March 19, 2010

Re: Lake County Water Authority – Lake Beauclair Aquatic Enhancement  
Environmental Resource Permit Application No. 35-0297532-001  
BCI Project No. 12-18116.16

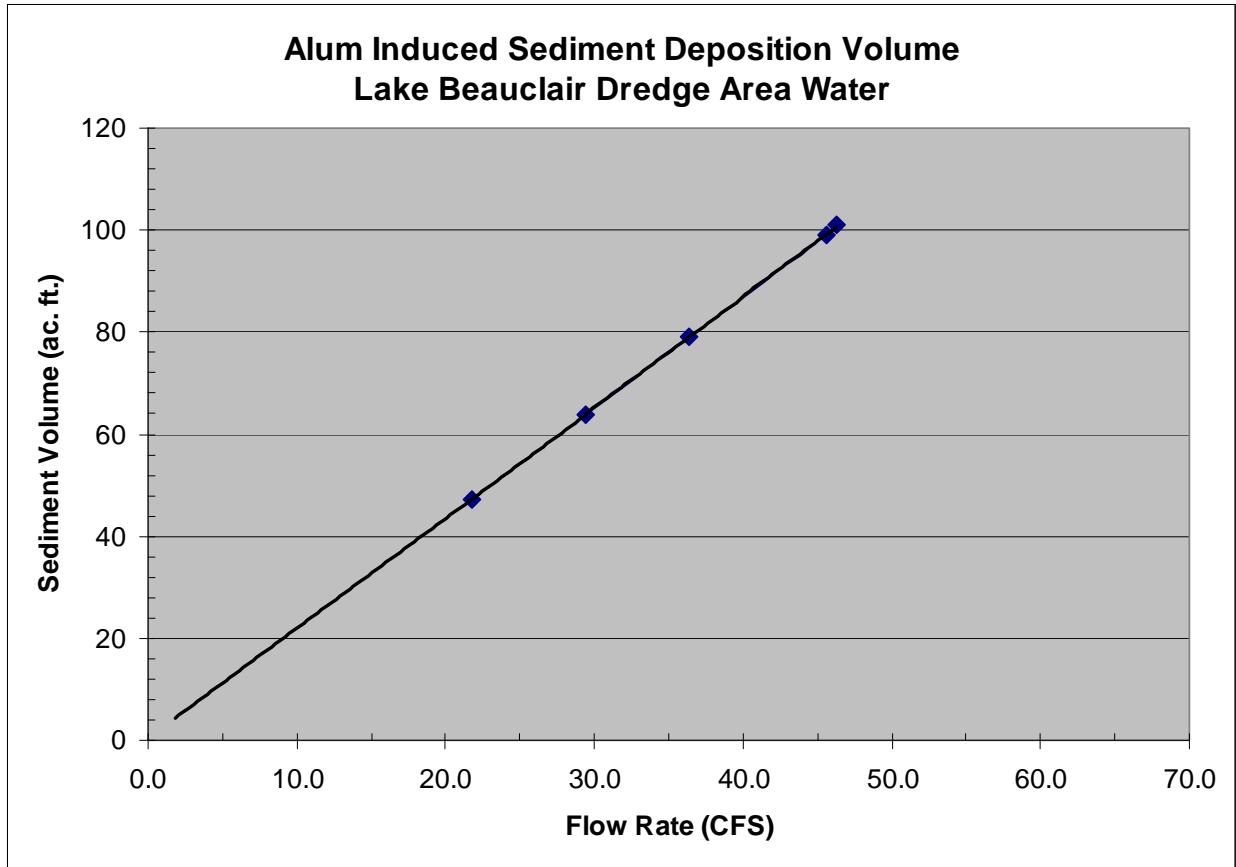
- 4. Will the polymers and alum discussed in the response to the previous RAI be added to the dredged materials as it discharges to cell F/G, or will it be added to the settling basin in the northeast corner of disposal cell G? How will pH and alkalinity be monitored and controlled? If these chemicals will be added to the settling basin, will sludge have to be removed? If so, where will the sludge be disposed?**

The discharge rate from the disposal area to the polishing basin is not expected to exceed 5,000 gpm. Plotting the data shown in the table, and by linear extrapolation rearward to the expected maximum flow rate of 5,000 gpm (11 cfs), we can expect that a maximum deposition of approximately 24 ac. ft. will occur over the 25 acre polishing basin. This is slightly less than a foot in thickness and will remain below the maximum prescribed elevation of deposited material discussed in previous submittals. The following graphic shows the sediment depth/flow rate correlation and rearward deposition projection.

Both aluminum sulfate and the polyacrylamides are somewhat acidic, with pH values generally between 4 and 5, and 5 and 7 respectively. However, at dilution ratios approaching 40,000:1, detection of any pH change resulting from treatment is highly unlikely.

Polishing basin discharge will be pumped to the NuRF, where pH and alkalinity will be monitored during pre-release treatment. Fluctuations in pH can be addressed by adjusting the alum injection rate to the system, and if necessary, by adjusting the rate of discharge to allow for appropriate pH recovery.
